## **EZ Hauler 3500/3800 Product Announcement**

**Subject:** Outrigger Gusset Update

**Announcement:** CCG1651

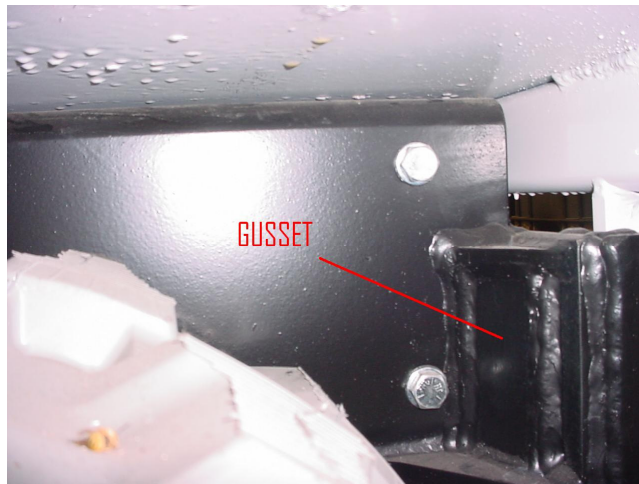
**EZ Hauler models 3500/3800 manufactured prior to June 1, 2006 may experience hydraulic outrigger structural damage when overloaded. Failure to update could result in total outrigger failure!**

**This mandatory update includes that gussets be welded in the backs of the outrigger body mounting plates on both the front and back of the unit. If you do not have this update, then you must call SDP Manufacturing, Inc., then they will supply you with the materials needed. The gussets will need welded in, so a qualified welder must do this work.**
